Subject: Contract [REDACTED]

ADVANCED FILM VIEWING LIGHT TABLE

A PROPOSAL FOR A FILM HOLD-DOWN PLATE

FIG. 1 FILM HOLD-DOWN PLATE

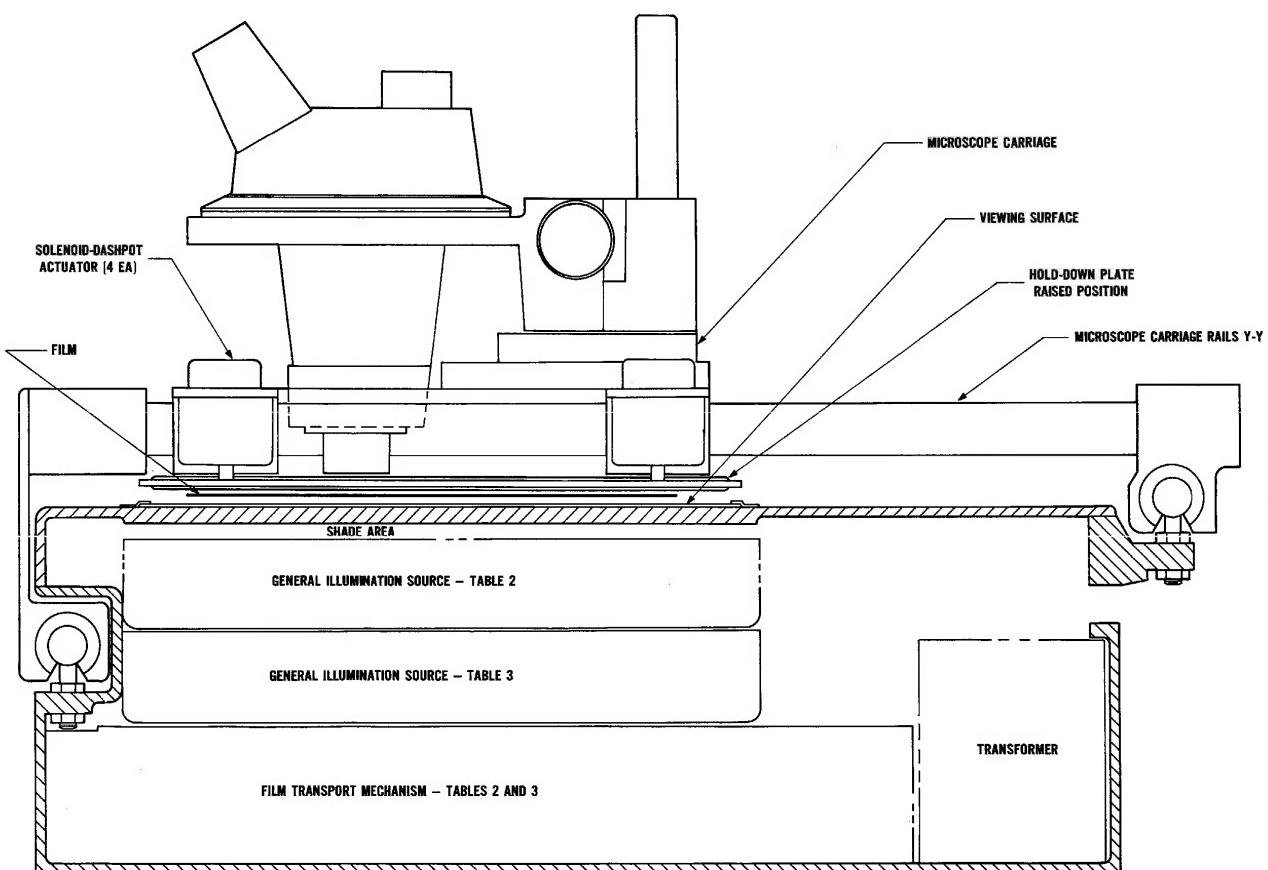
STATINTL An investigation of various types of roll film by [REDACTED] personnel showed that film can camber as much as 3/4" when extended over a 47-inch length. The film hold-down bars as proposed by [REDACTED] in Proposal P-3801 will accomplish little in removing this camber because they are located at each end of the 40" viewing surface. On light tables #2 and #3 it will be virtually impossible to maintain focus of the stereoscopes over any 2 cm. of travel unless the film is held flat against the viewing surface. Using instruments having an extremely small depth of focus, such as the [REDACTED] Stereoscope, will require the interpreter to continually change the instrument focus during image measurement.

STATINTL As a solution to this problem [REDACTED] proposed to install an optically flat glass hold-down plate of quality optical glass, (see Figure 1) lapped and polished to a flatness of 6 fringes. The hold-down plate will be mounted to the course Y-Y microscope carriage and transported over the entire viewing surface of the light table as the microscope is transported by the operator. The plate will be supported in a mounting frame with the frame attached to the course Y-Y microscope carriage by four solenoid-dashpots (see Figure 2). When a target area is spotted on the film, the solenoids will be energized and the hold-down plate slowly lowered (3-5 seconds) to compress the film flat on the viewing surface. Actuation will be by foot switch or hand switch, depending upon the desire of the customer. An electrical interlock will be incorporated into the lifting mechanism to prevent the inadvertent transport of film while the hold-down plate is bearing on the film. This will be accomplished by de-energizing the clutch mechanism in the film transport system. A second interlock will be incorporated on the microscope stage locks for the course adjustments to prevent the operator from moving the microscope stage in course X or Y with the hold-down plate in the down position. When the stage is unlocked in either course X or Y, the hold-down plate will lift itself automatically.
